DONCASTER BEVERLY DANBURY RECONSTRUCTION

CITY PROJECT NO. 14079
CONTRACT NO. 8709

ADDENDUM #1- 5/17/2024
REVISED THE FOLLOWING:
TITLE SHEET
SHEETS G12-G15
SHEETS PD1-PD2, PD5-PD6
SHEETS P1-P2, P5-P6
SHEET U2-U6
REMOVED THE FOLLOWING:
SHEETS G12 AND G16

MARK	REVISION	DATE	BY
AD#1		5/17/24	MFG
14079	14079	5/17/2024 10:37 AM	PD-1

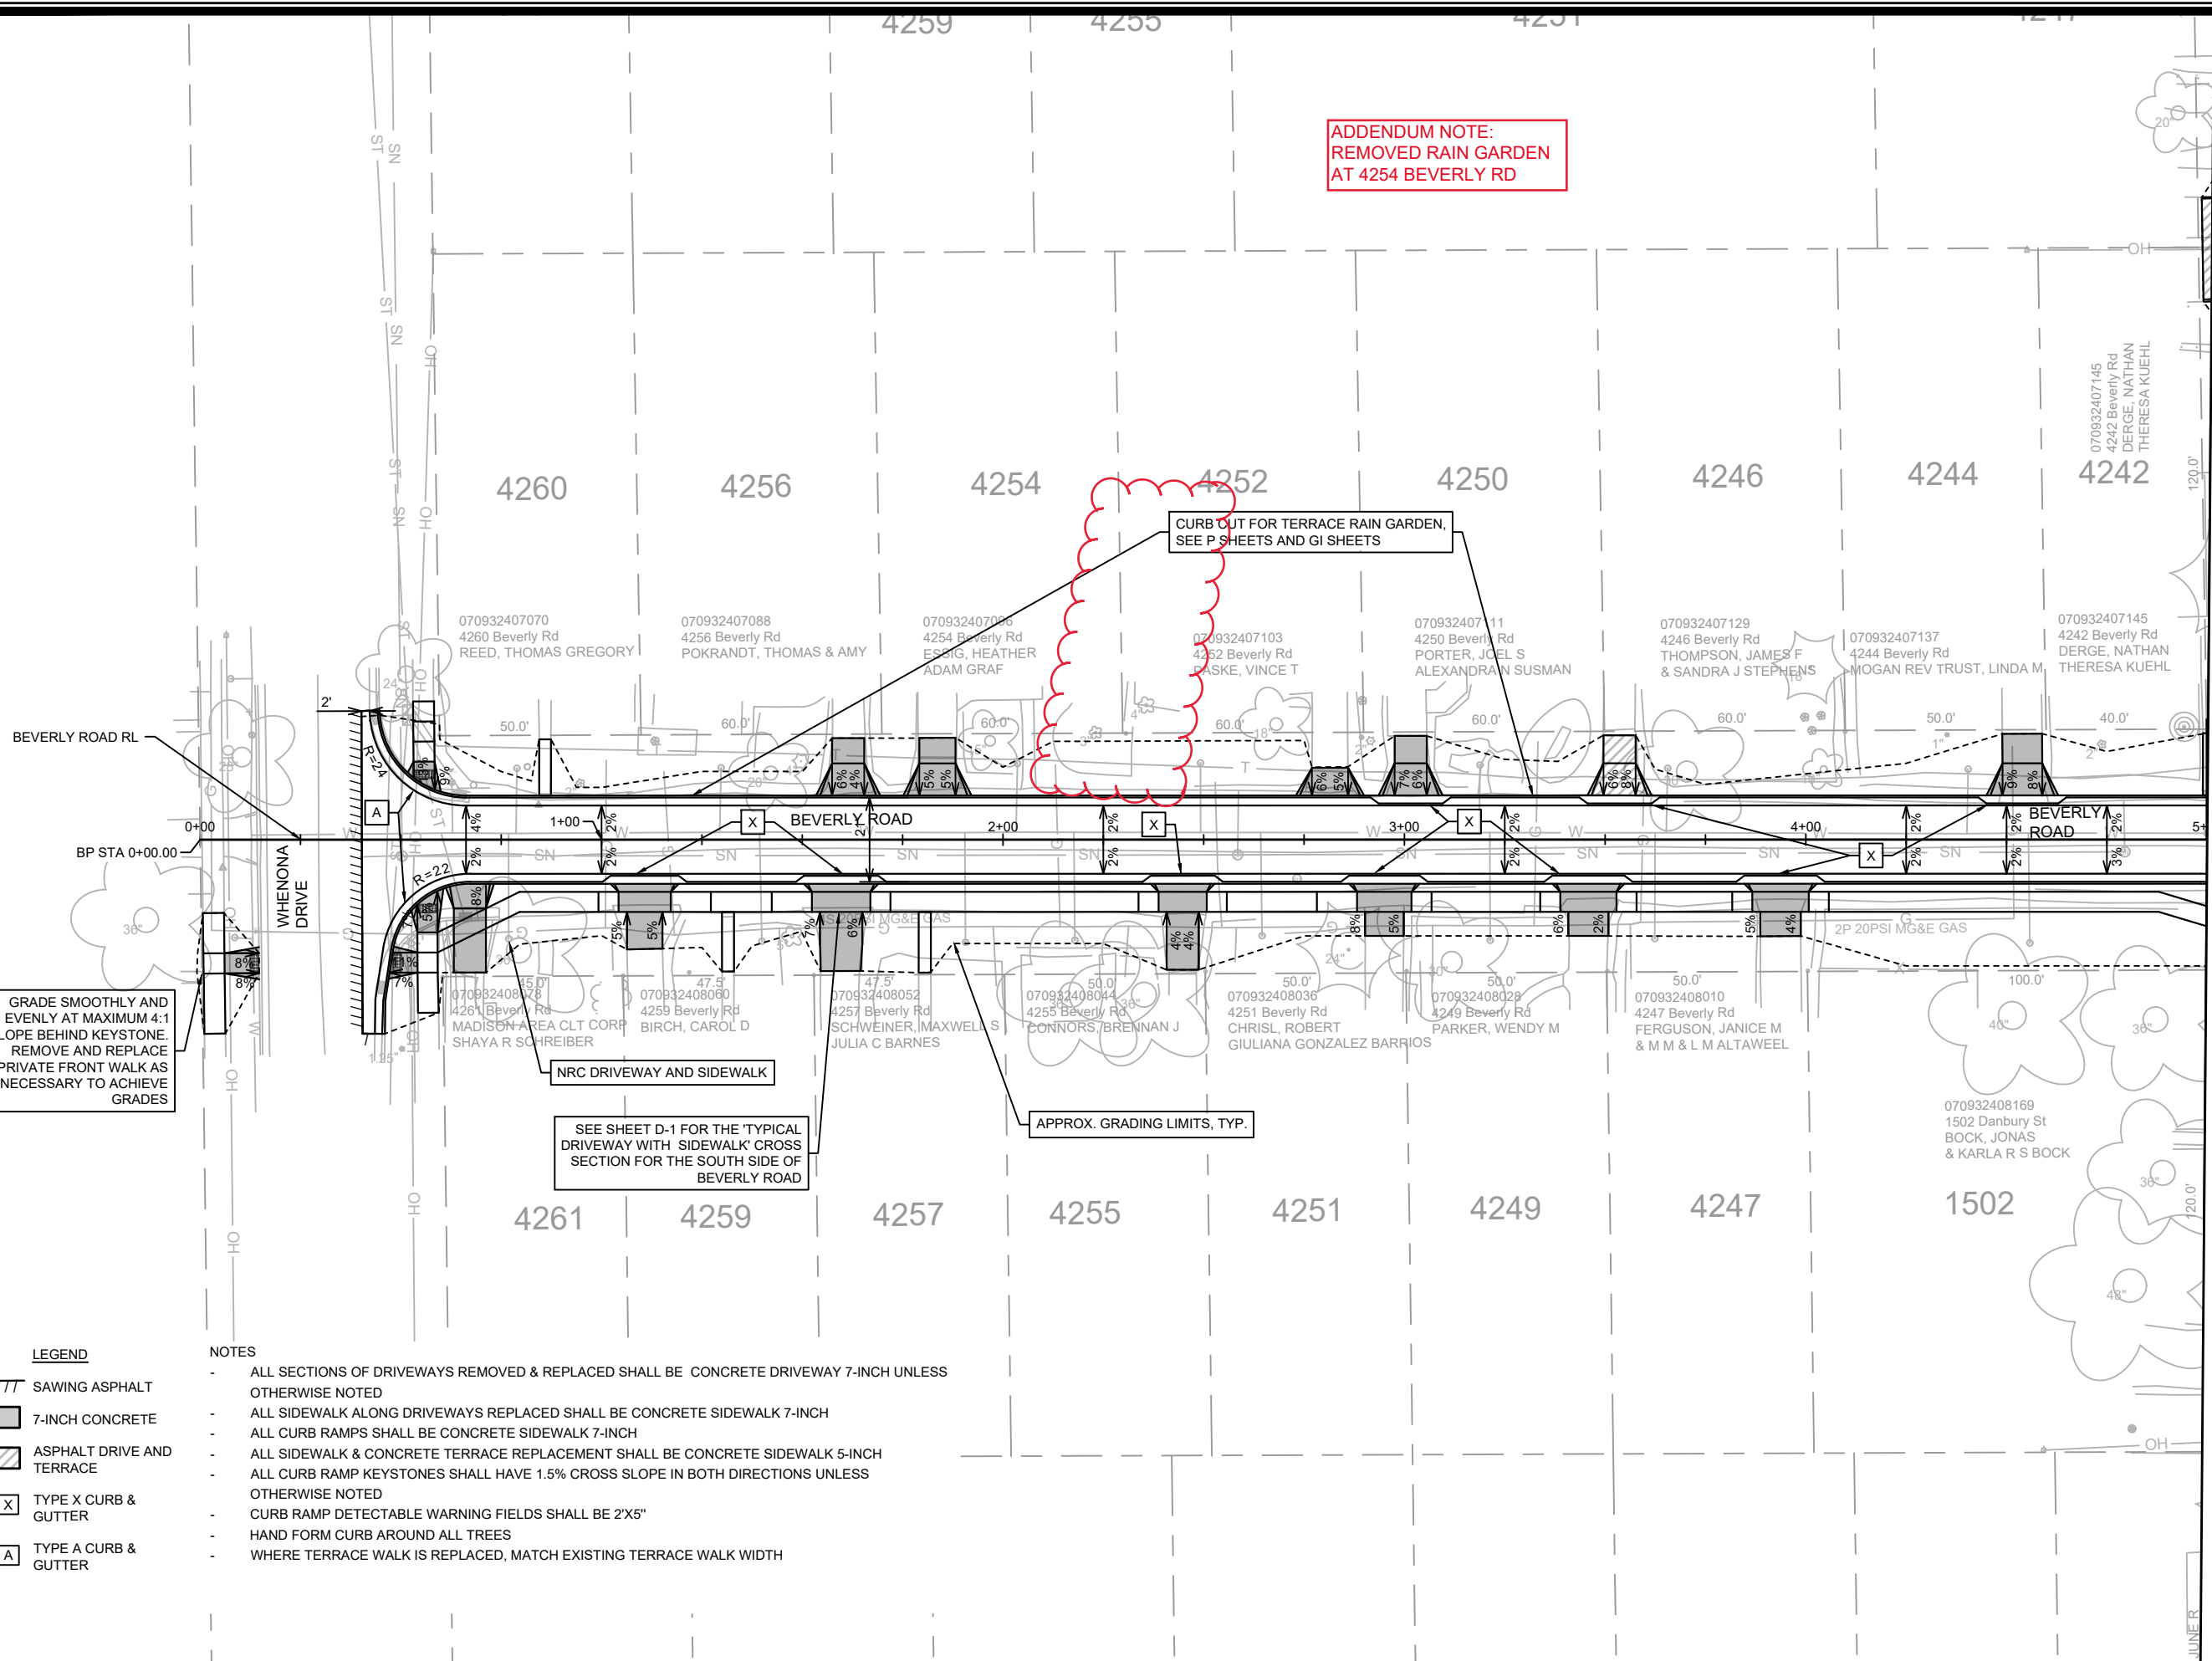
ADDENDUM NOTE:
REMOVED RAIN GARDEN
AT 4254 BEVERLY RD

MARK	REVISION	DATE	BY
AD#1		5/17/24	MFG
14079	14079	5/17/2024	10:37 AM
Designed By: MFG			Scale: 1" = 40'
Contract No: 8709			PD-2

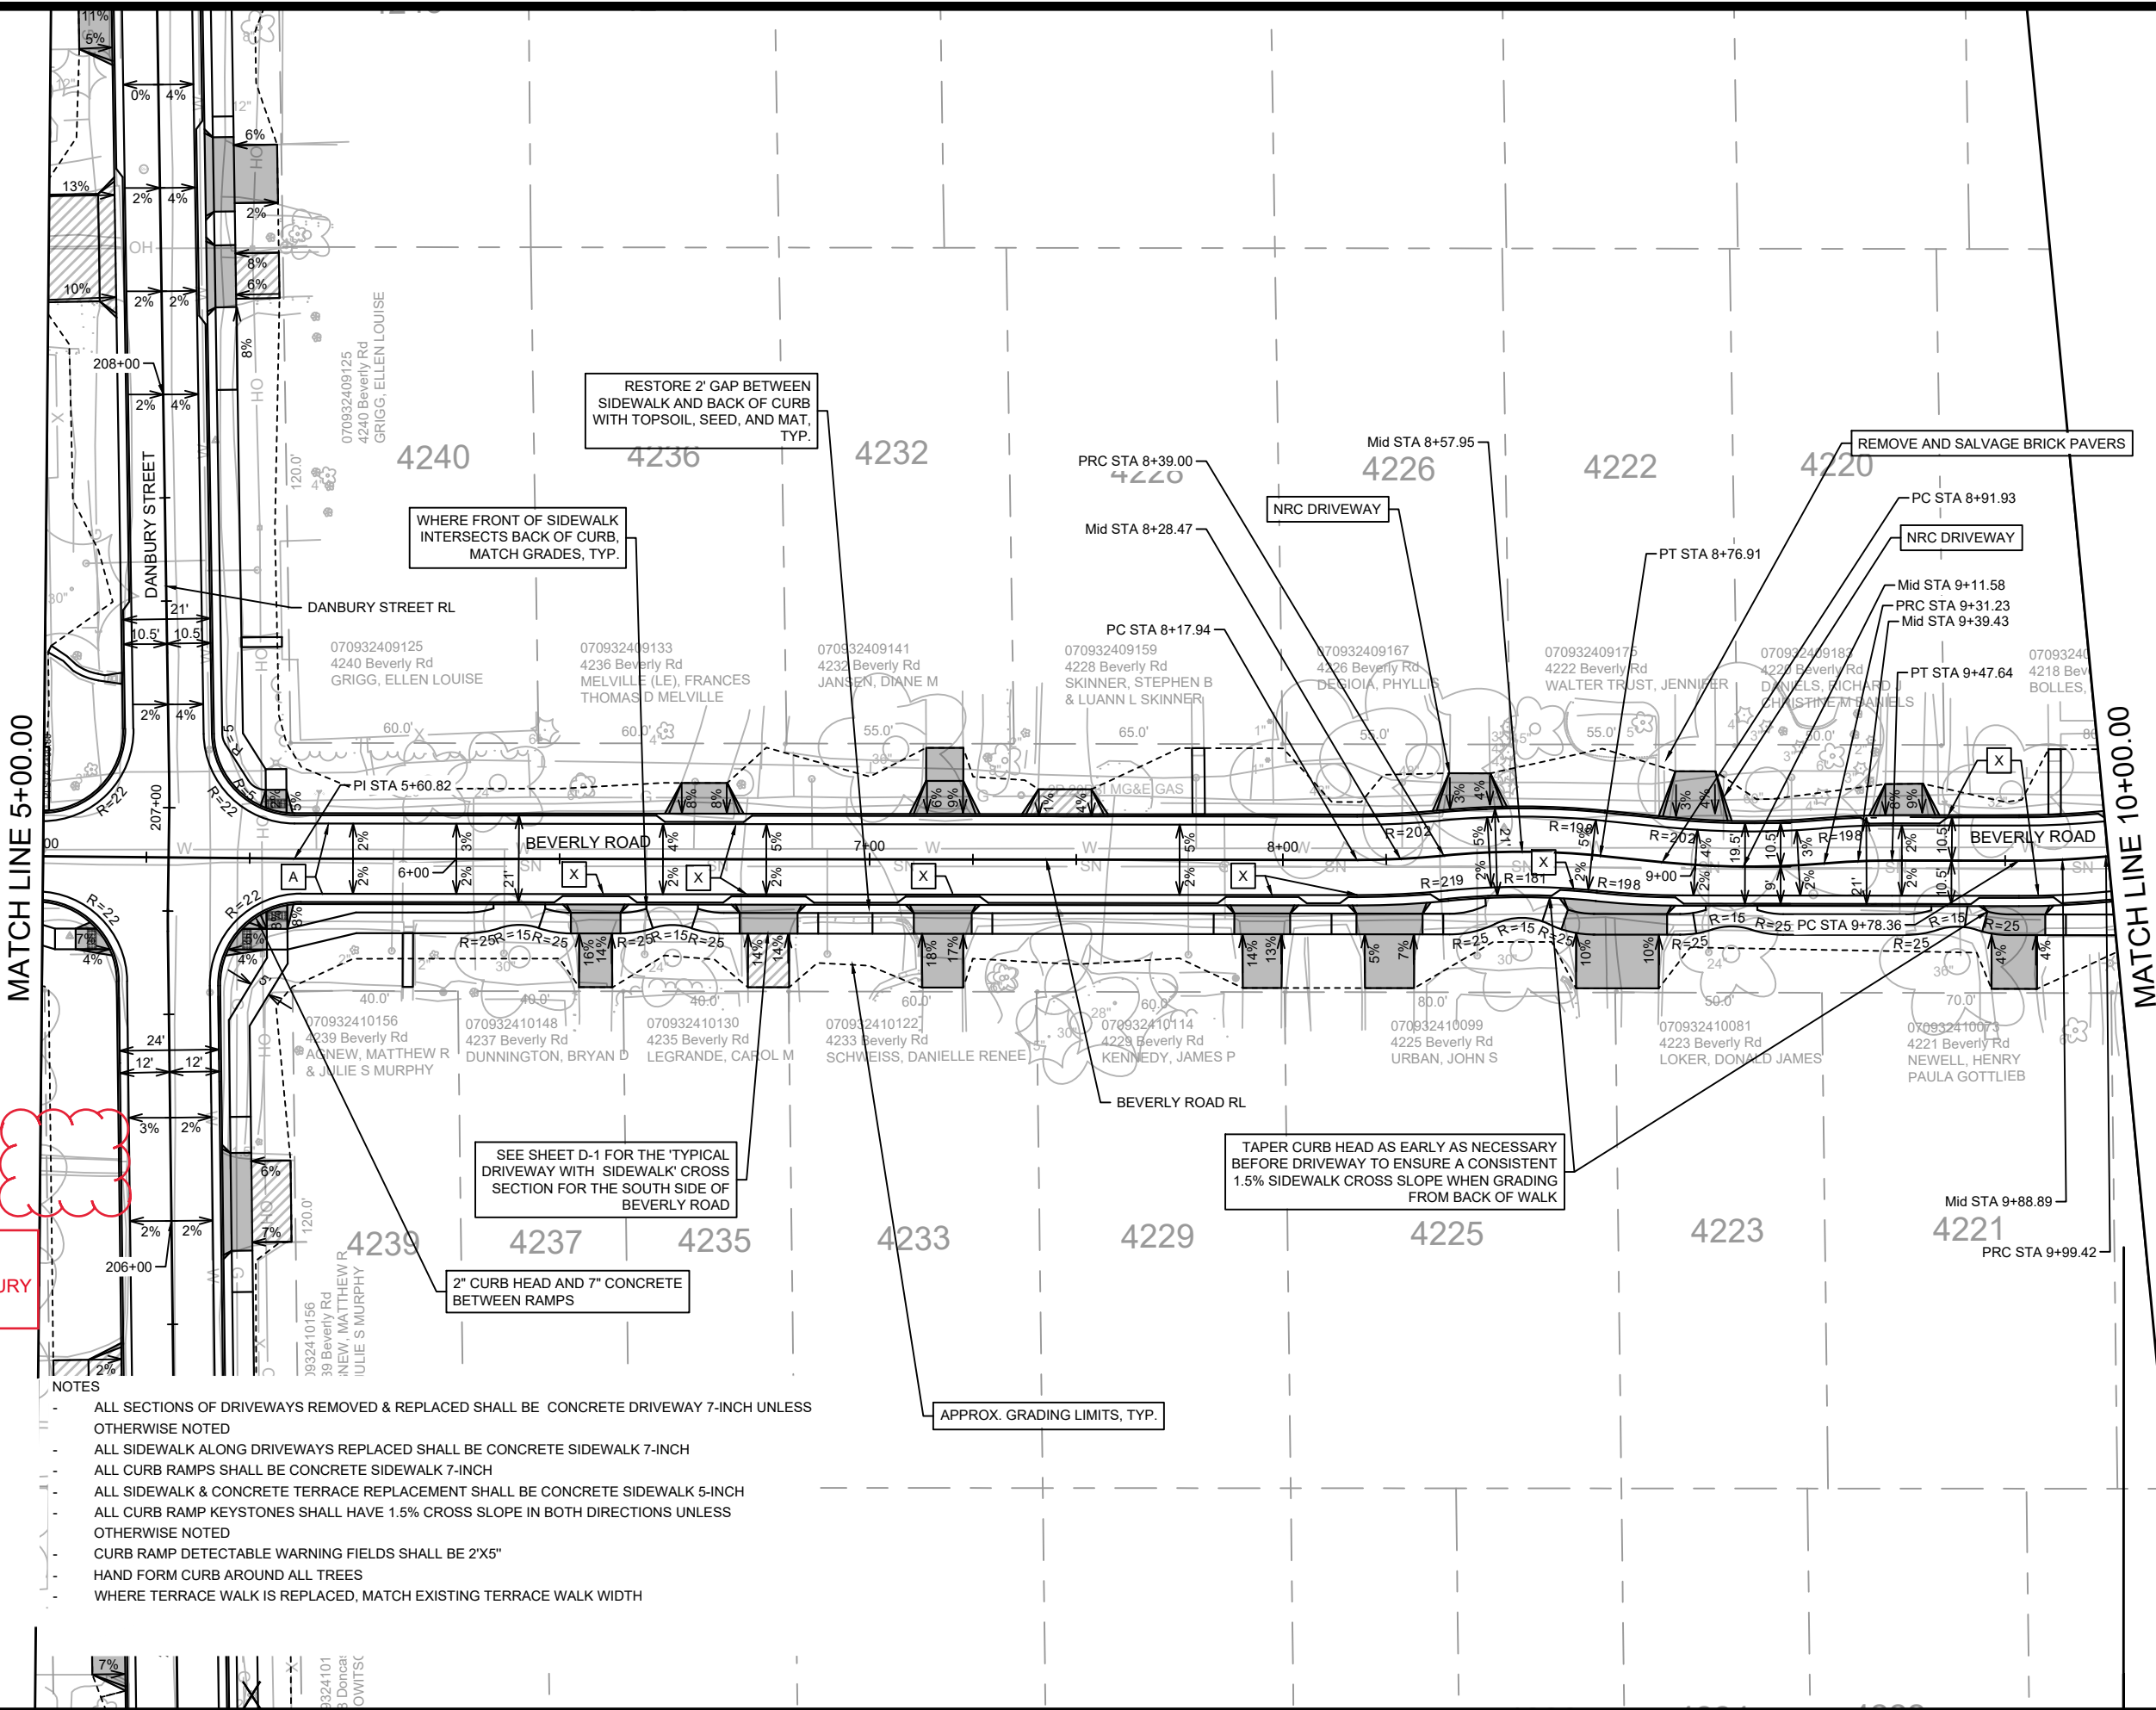
ADDENDUM NOTE:
REMOVED TERRACE
WALK AT 1502 DANBURY
ST

14079
PD-5

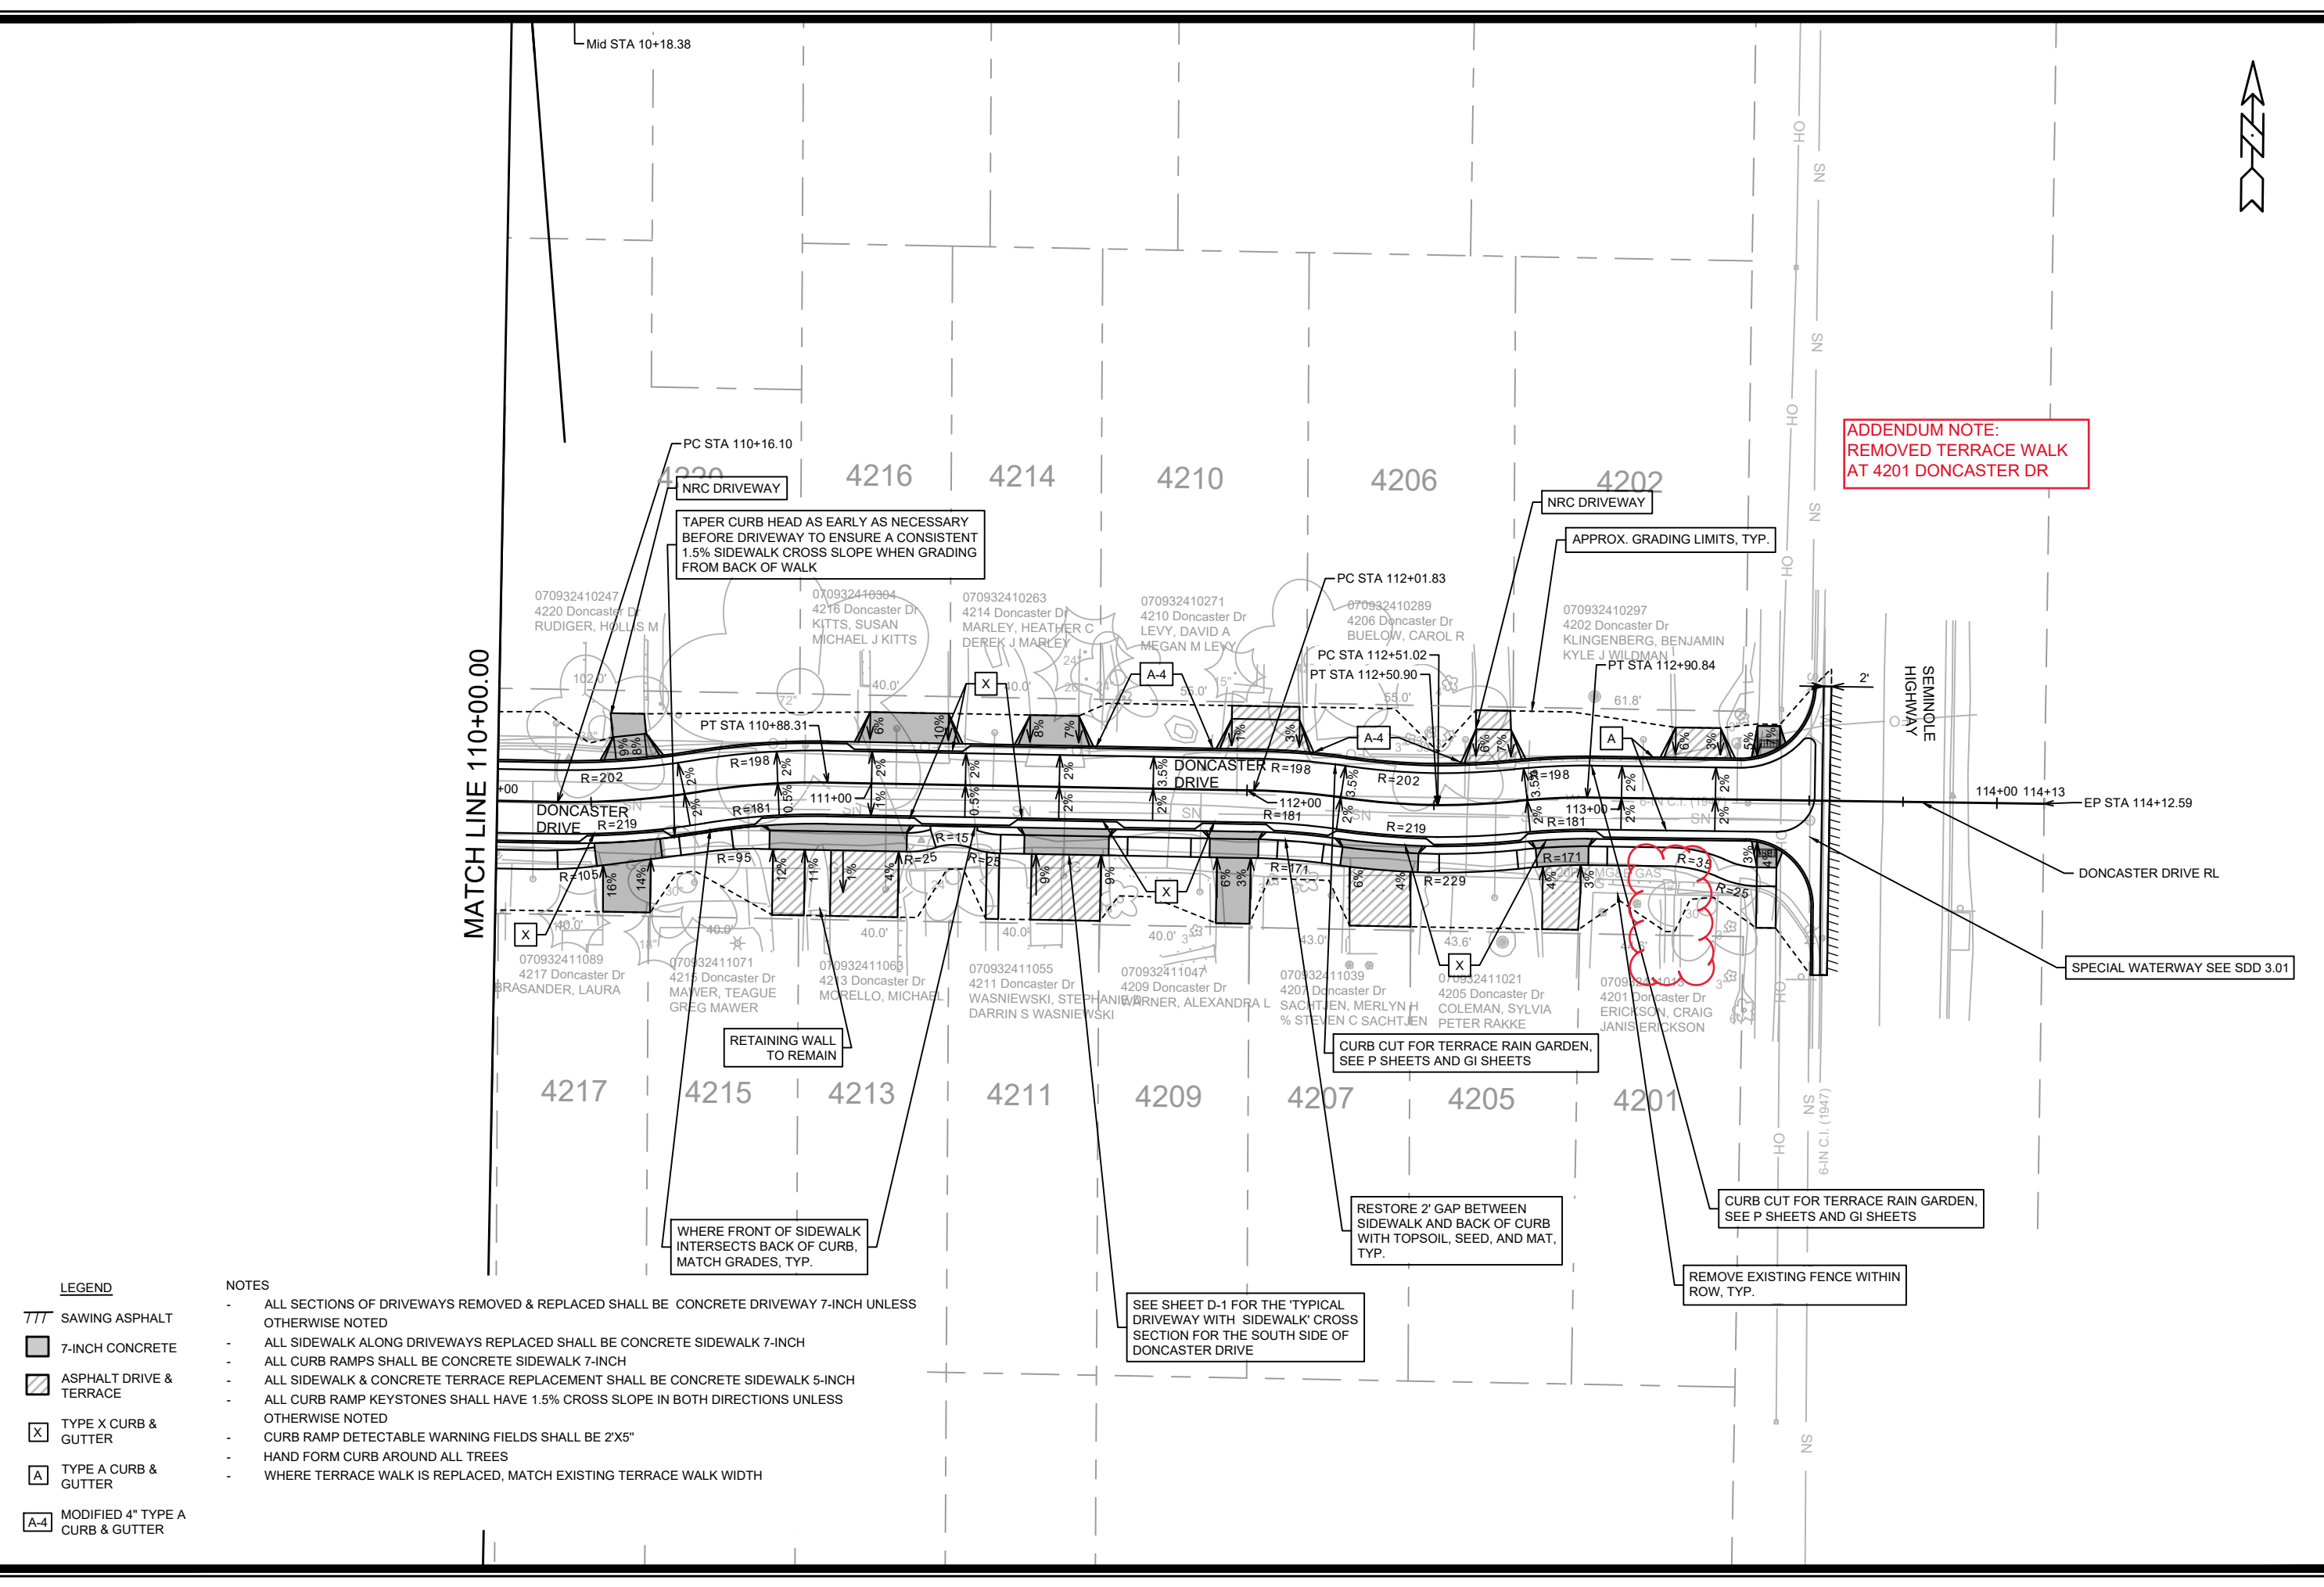
**ADDENDUM NOTE:
REMOVED TERRACE WALK
AT 4201 DONCASTER DR**
